MEMORANDUM

Date: January 06, 2015
To: David Bonk, Kumar Neppalli, PE
Town of Chapel Hill, North Carolina
From: Bill Schultheiss, PE
Re: South Columbia Street and Otey's Road Safety Review and Concept Development

Toole Design Group (TDG) was retained by the Town of Chapel Hill to review a concept design developed by Kimley-Horn and Associates, Inc. (KHI) at the northern intersection of South Columbia Street at Fordham Boulevard (attached as exhibit 2), to develop concept design alternatives for South Columbia Street from Purefoy Road to Culver Road, and to develop a crossing improvement concept for Otey's Road at Fordham Boulevard.

SHEET NAME:
S. COLUMBIA AT
FORDHAM BLVD
WESTBOUND RAMP
DRAWING NUMBER
SK-4
SHEET NUMBER
4 OF **13**

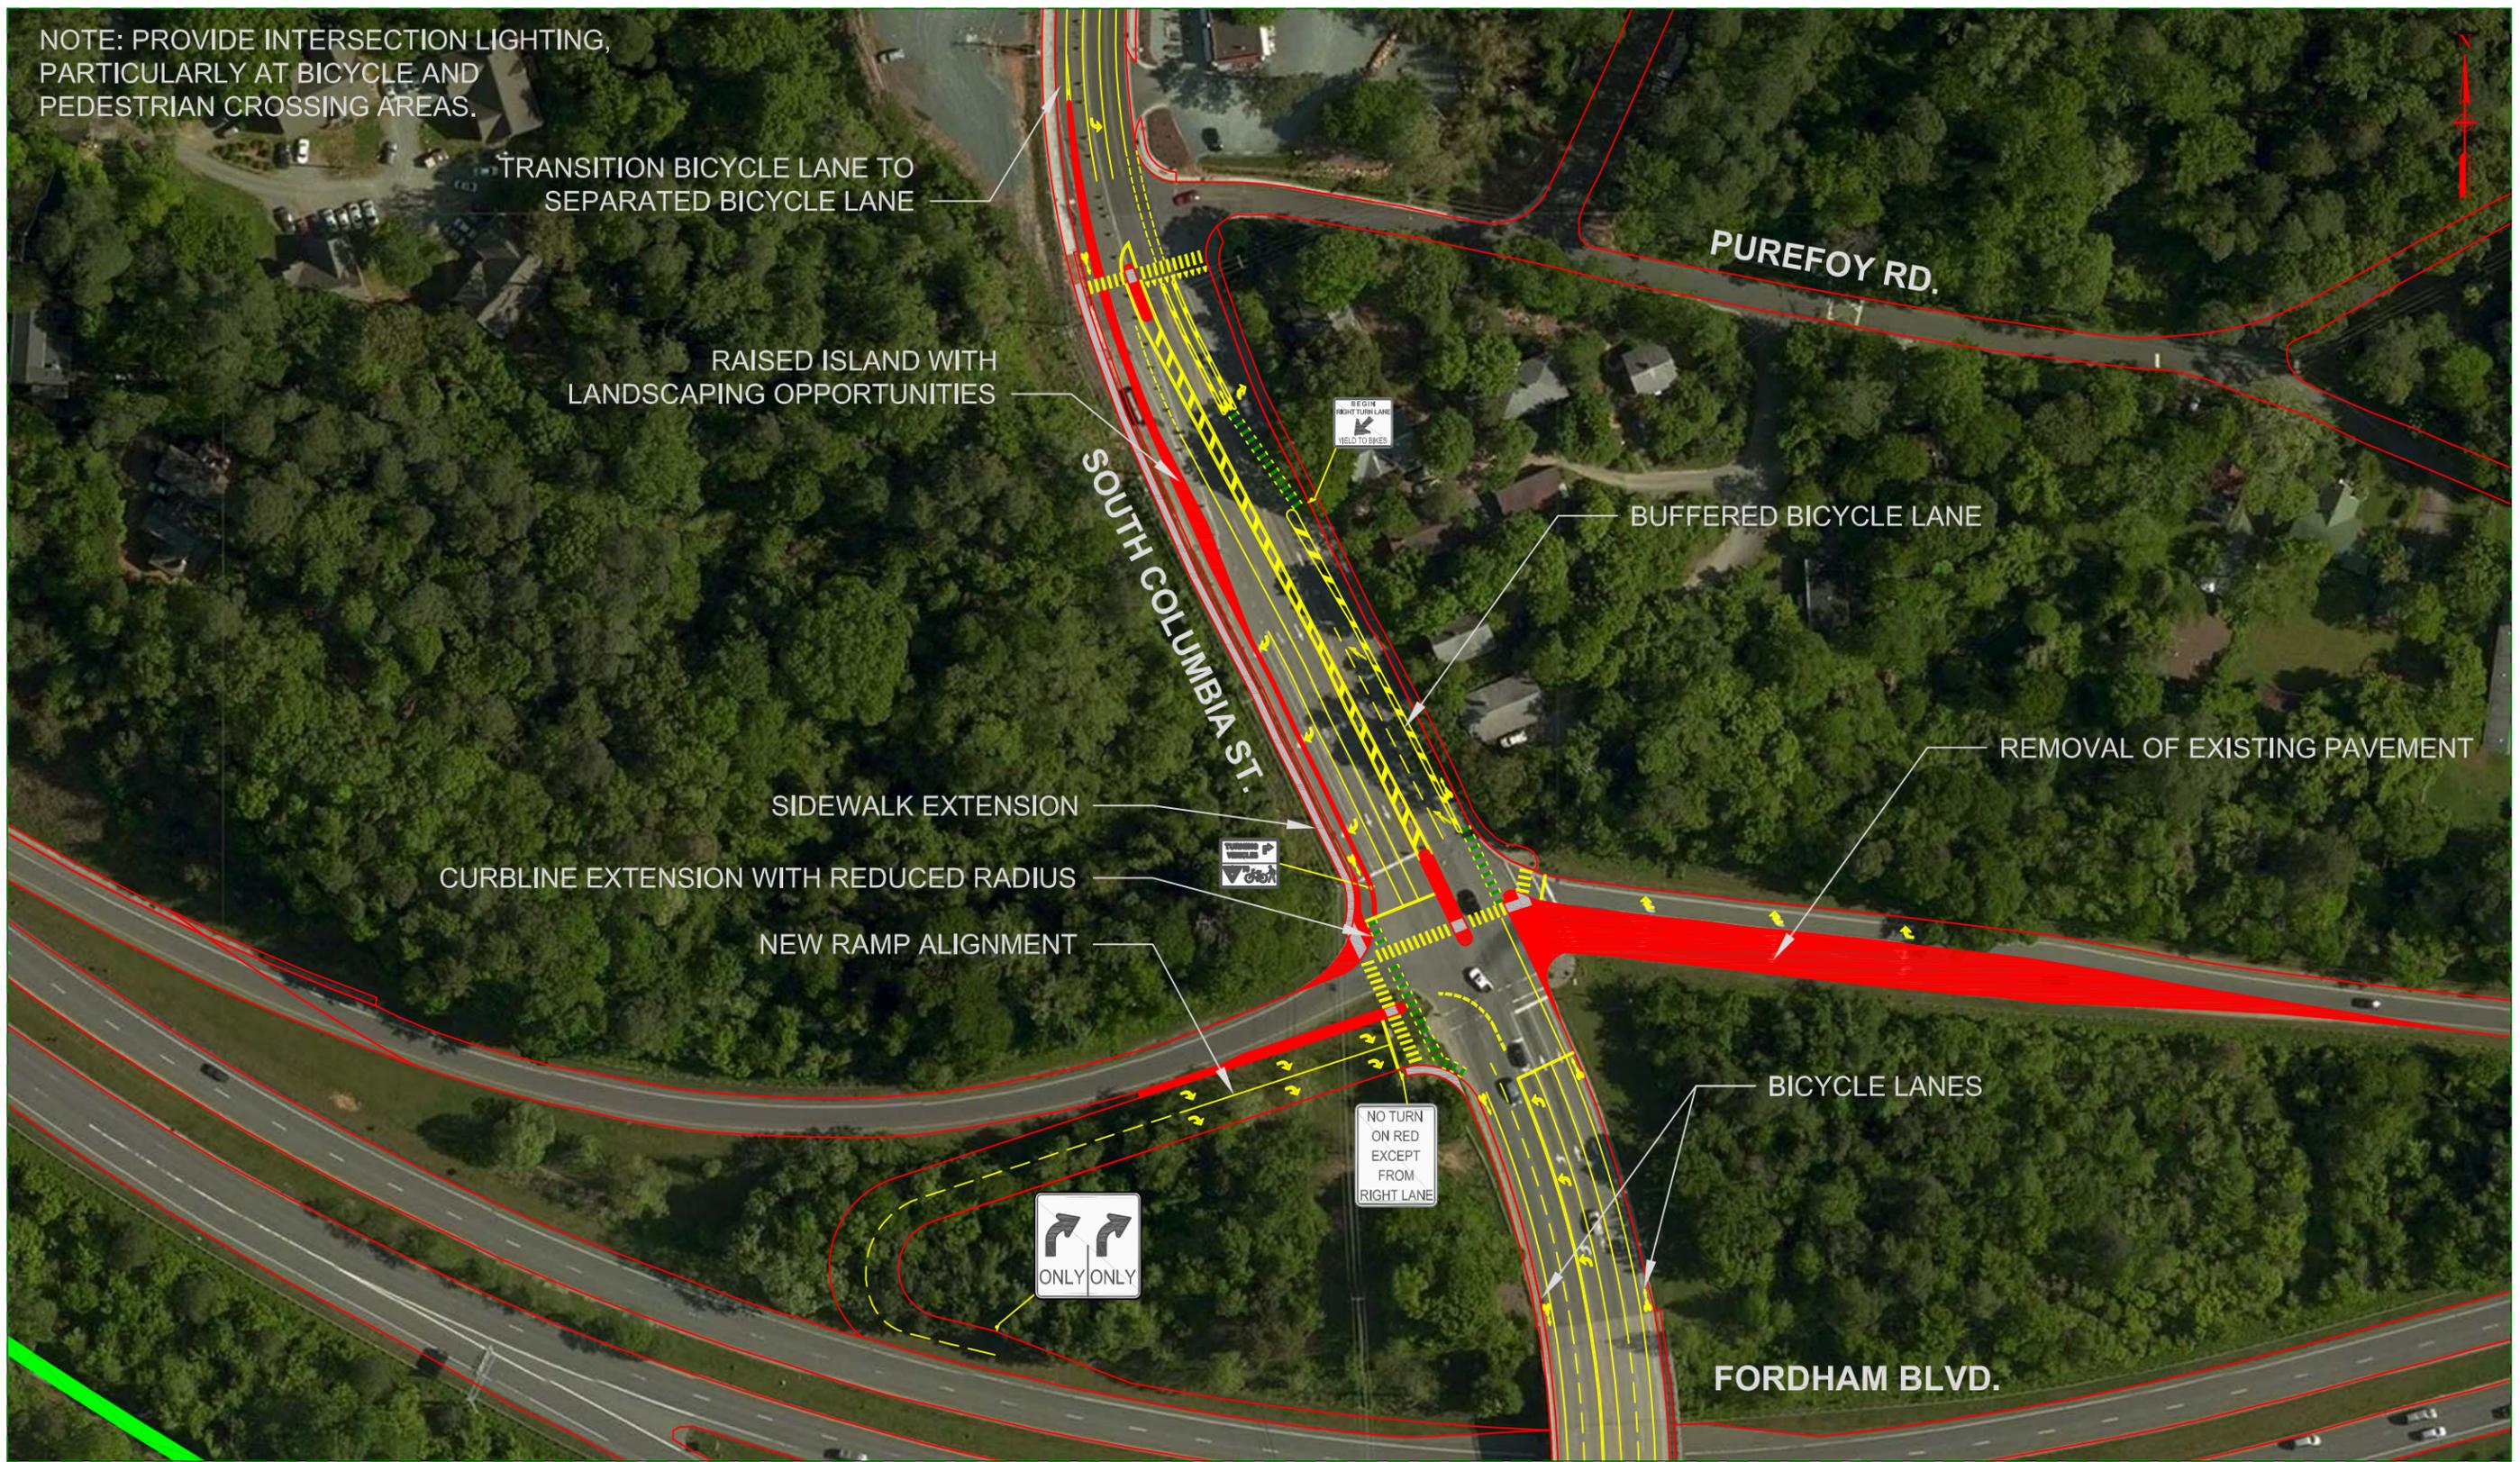
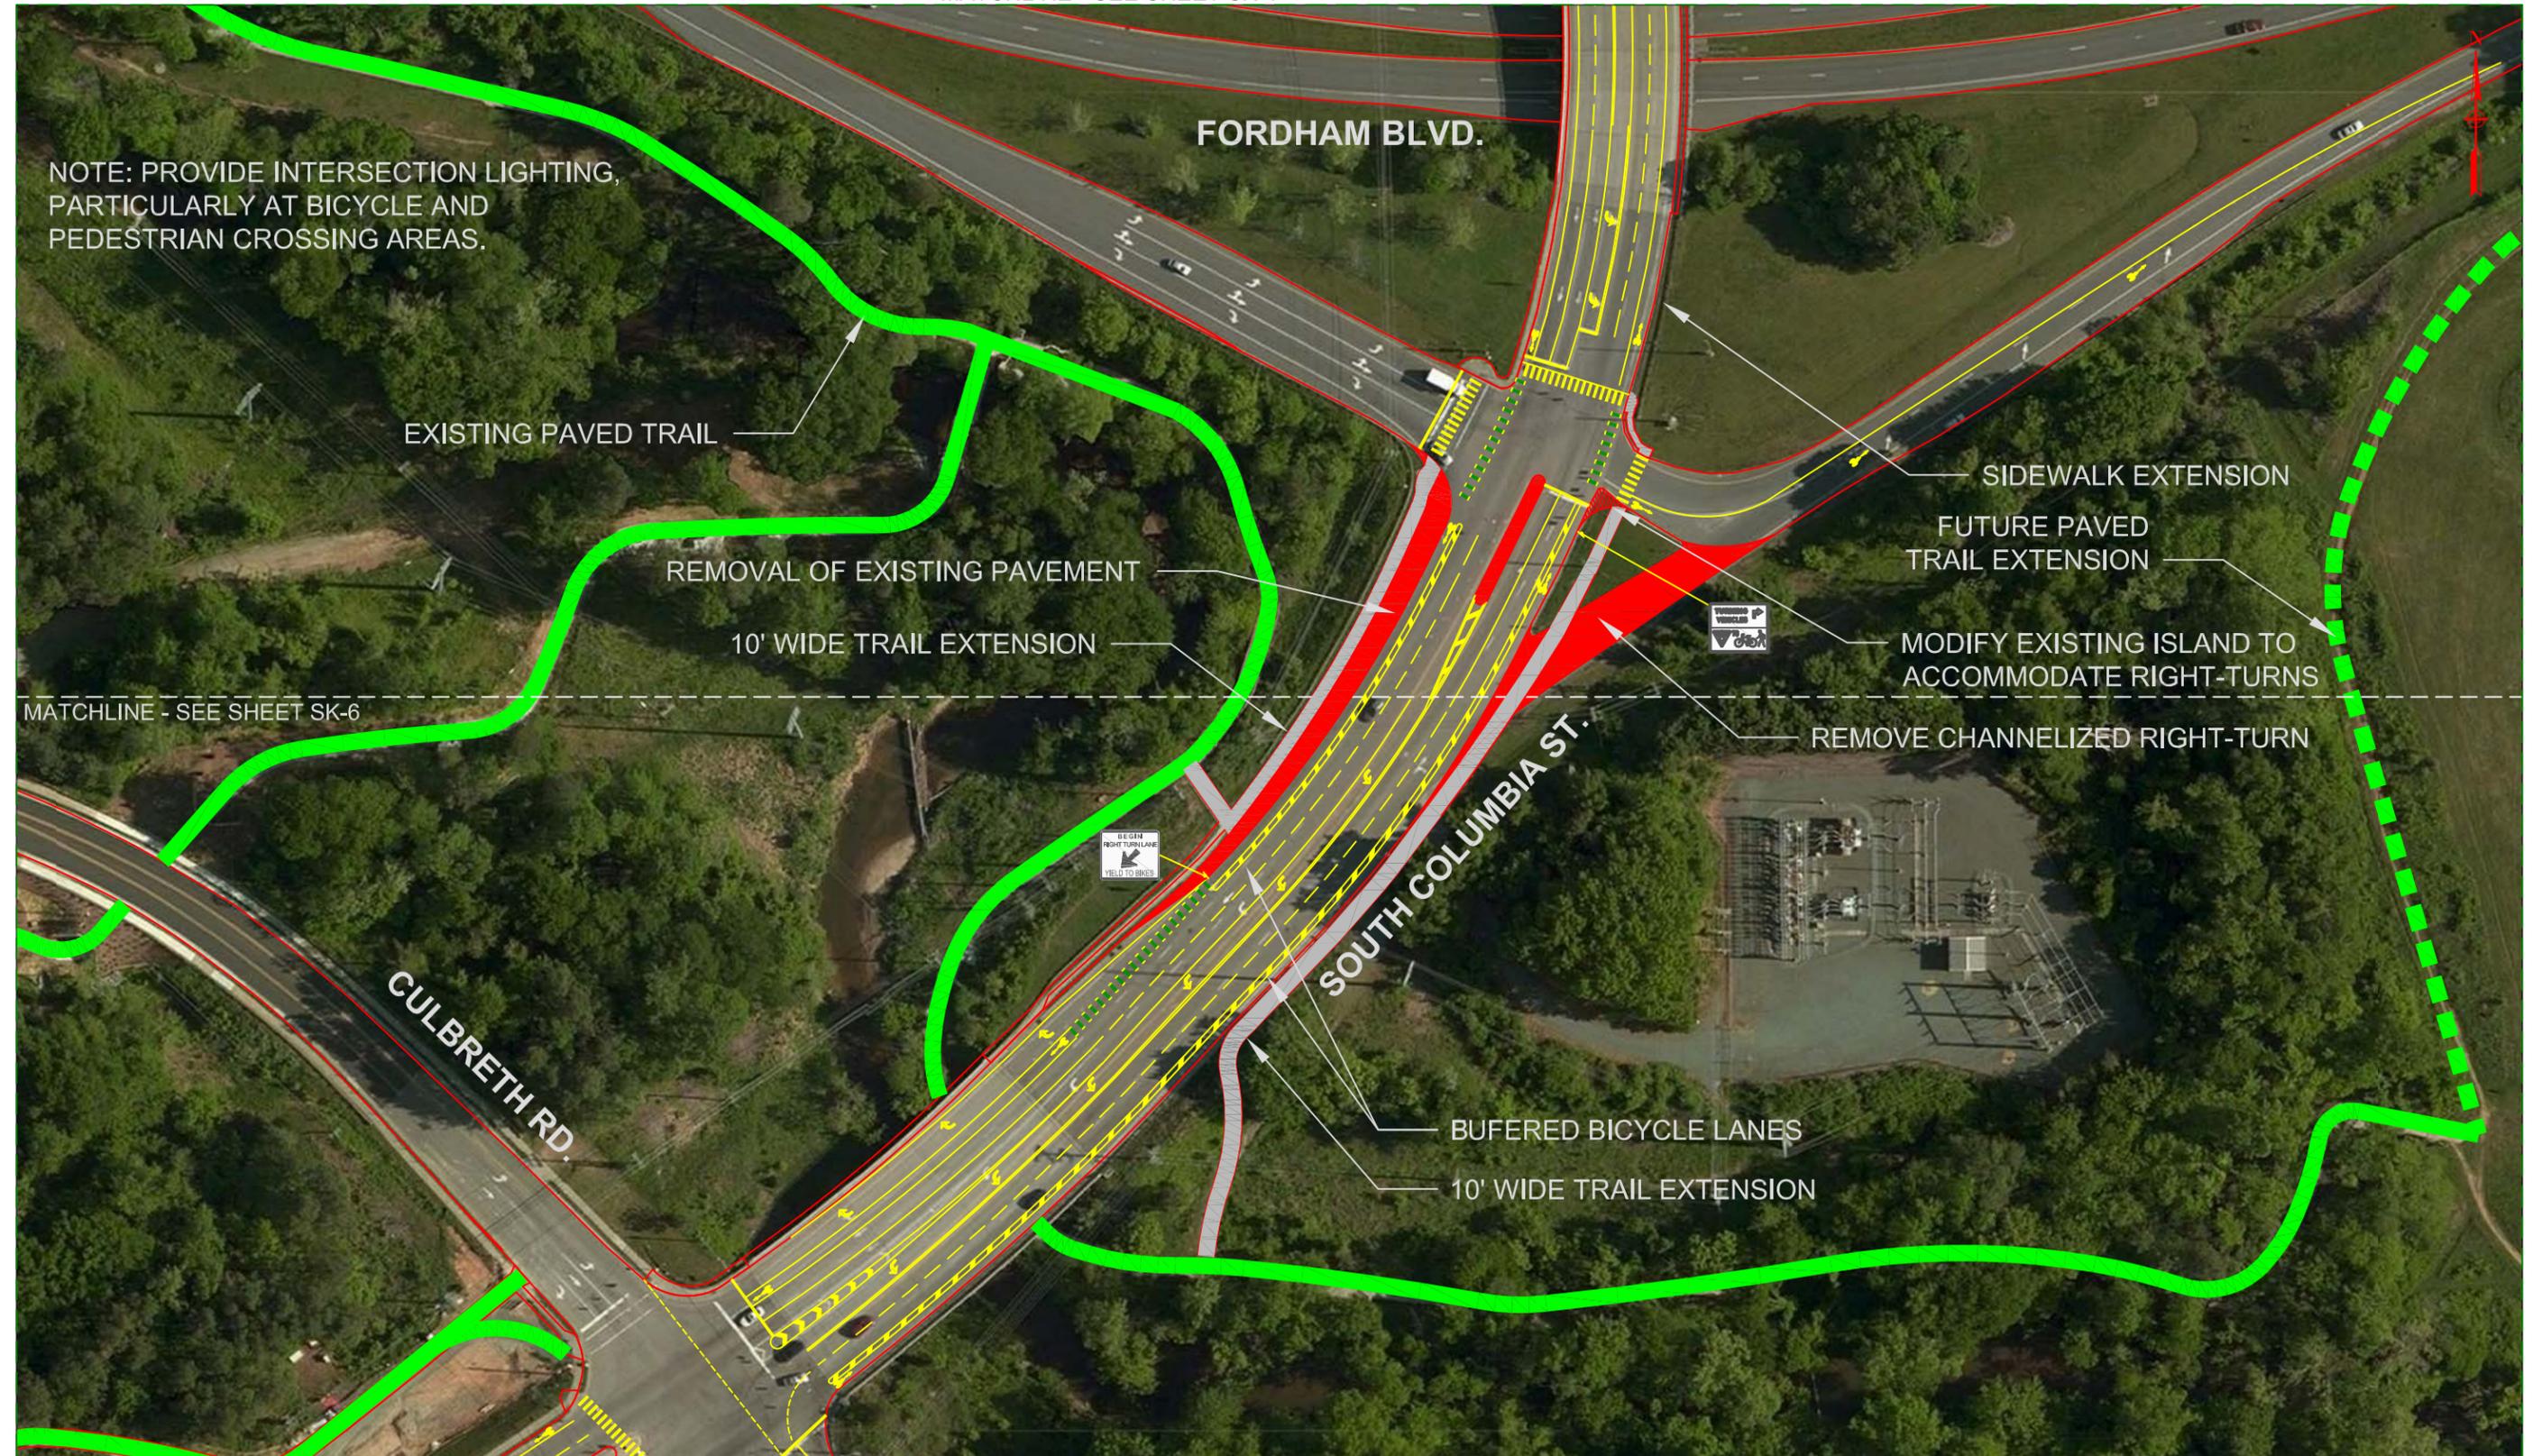
Alternative 2 depicts includes many of the recommendations from Alternative 1, but provides a higher level of change by removing all slip ramp designs. Additionally for southbound bicyclists, the bicycle lane is replaced by a

curb protected bicycle lane. The curb protected bicycle lane replaces the extended merging area with a single conflict point the combined bicycle and pedestrian crossing. The design of the corner promotes yielding by reducing bicyclists approach speeds and motorists turning speeds.

SHEET NAME:
 S. COLUMBIA AT
 FORDHAM BLVD
 EASTBOUND RAMP
 DRAWING NUMBER
SK-10
 SHEET NUMBER
10 OF **13**

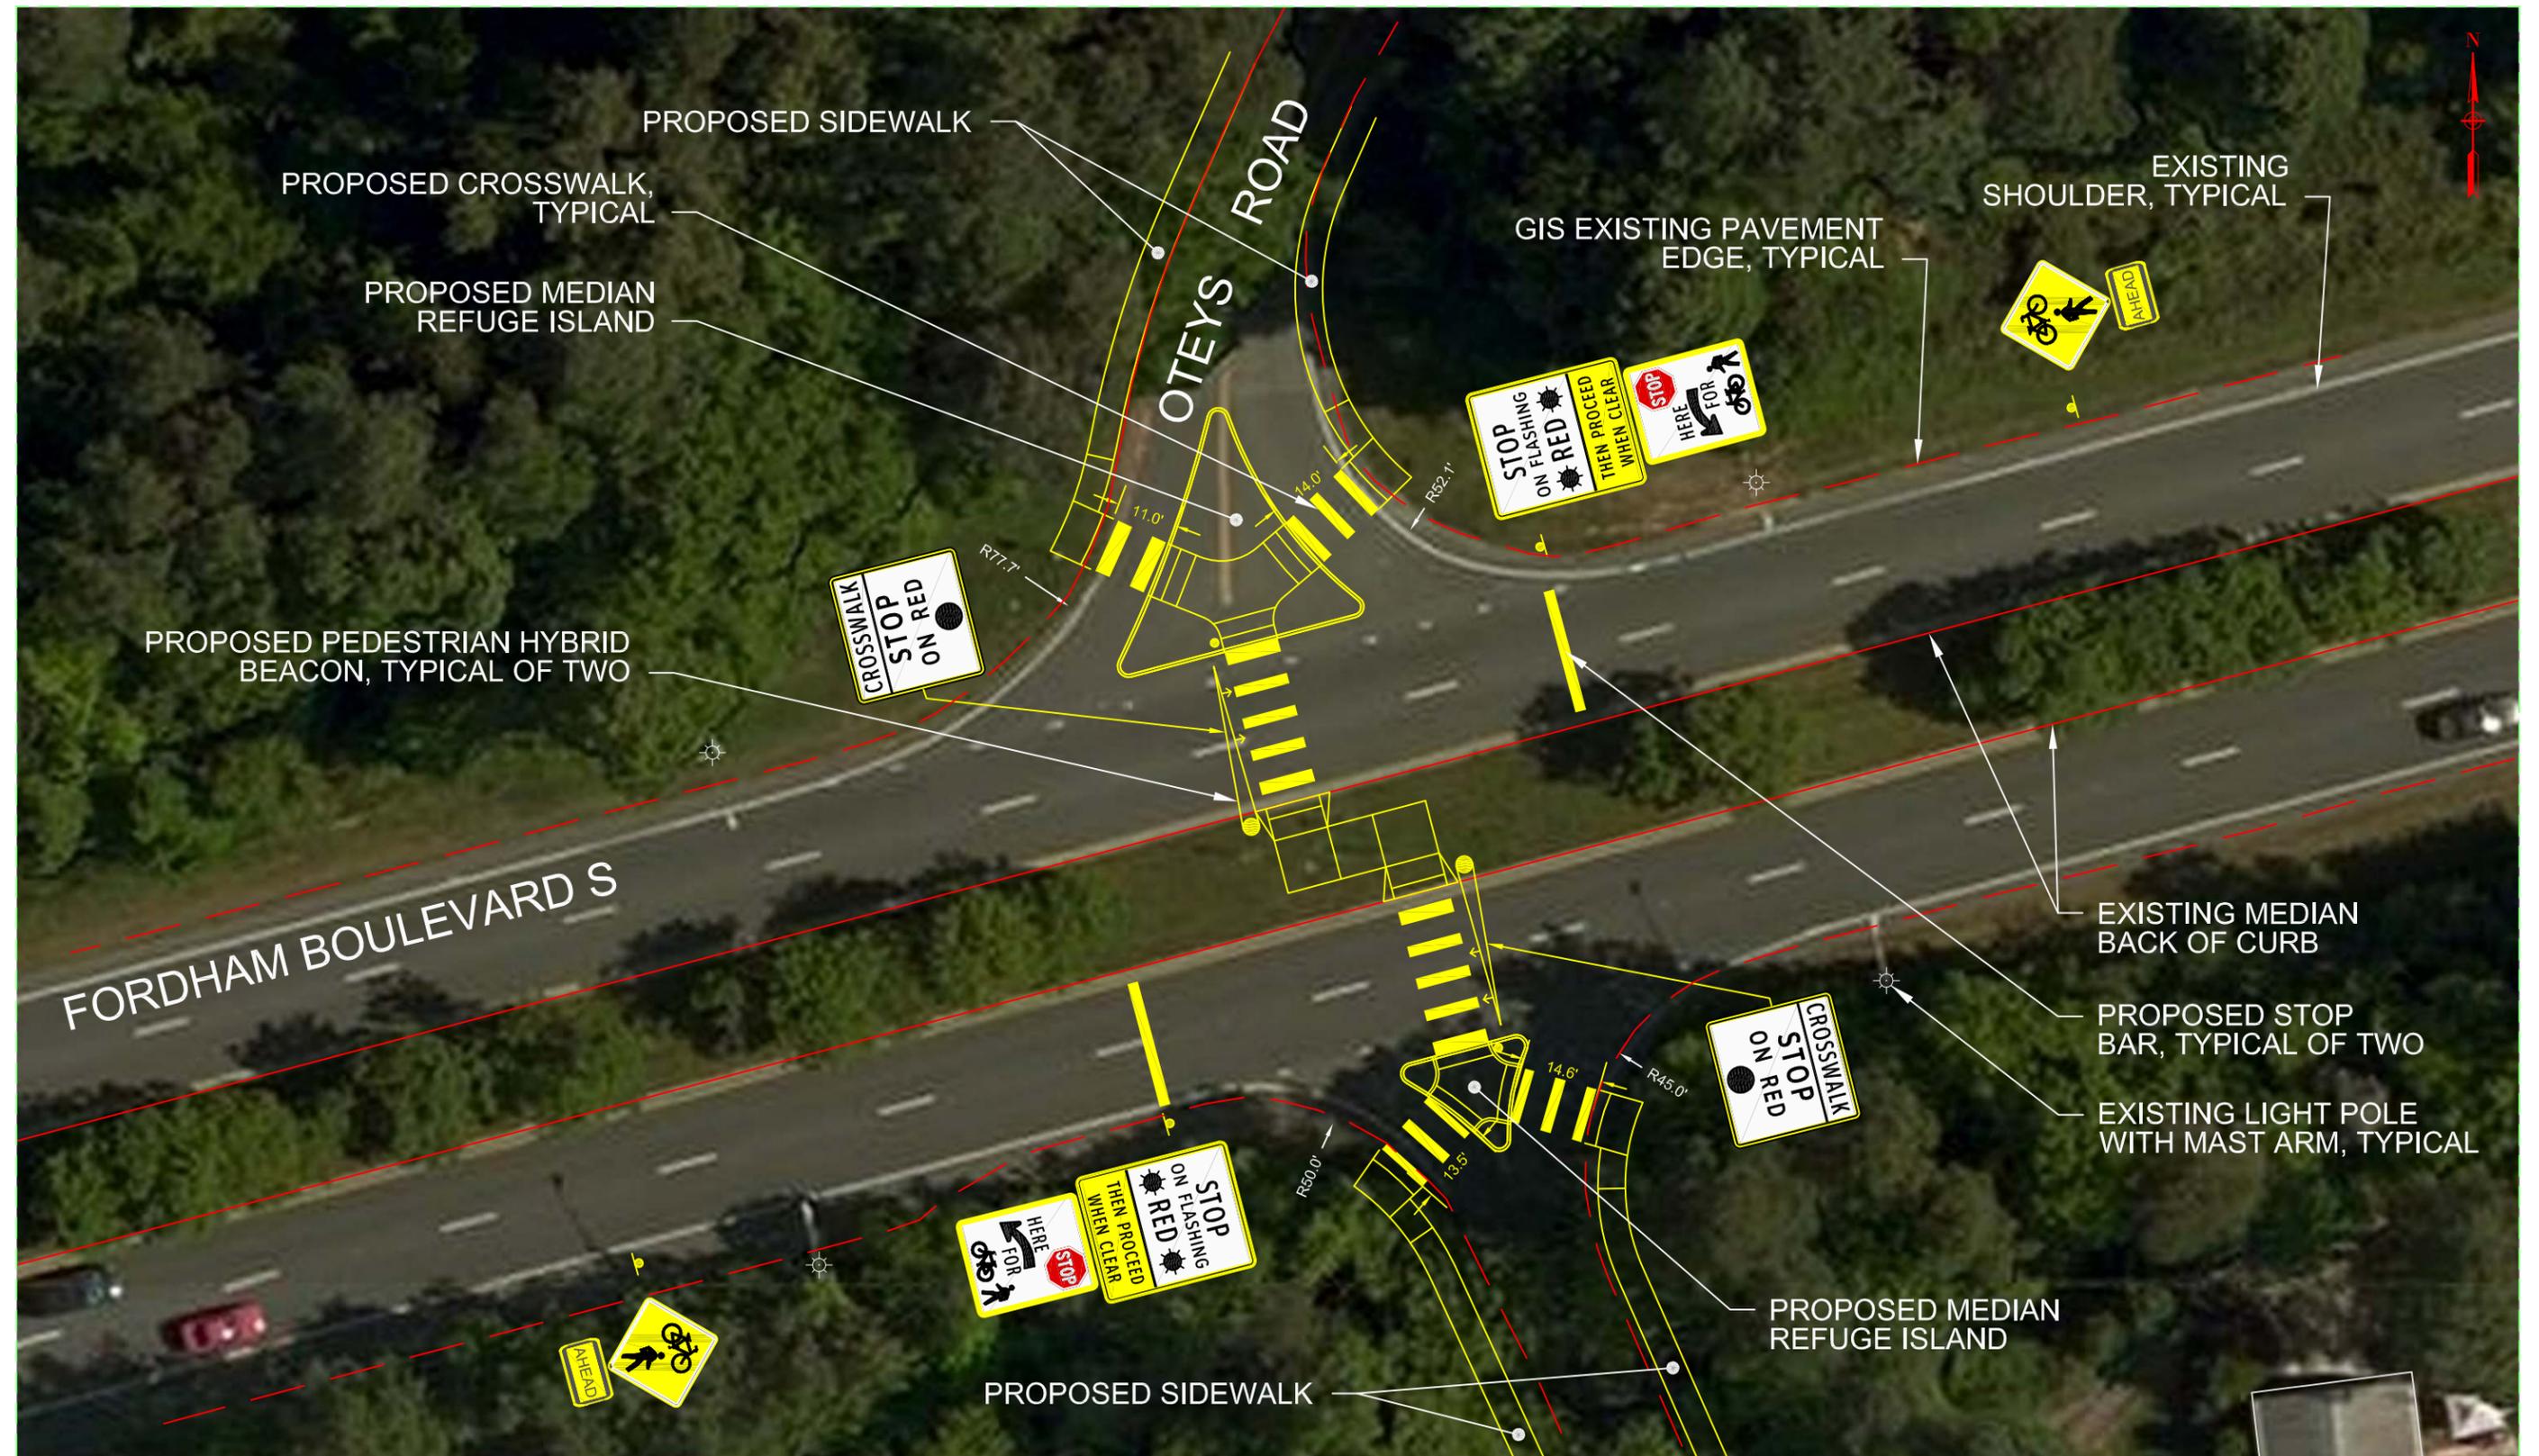
An interim alternative was developed to allow the implementation of Alternative 1 with changes restricted to pavement markings and signs. This concept removes all curb changes thus it does not address many of the pedestrian needs.
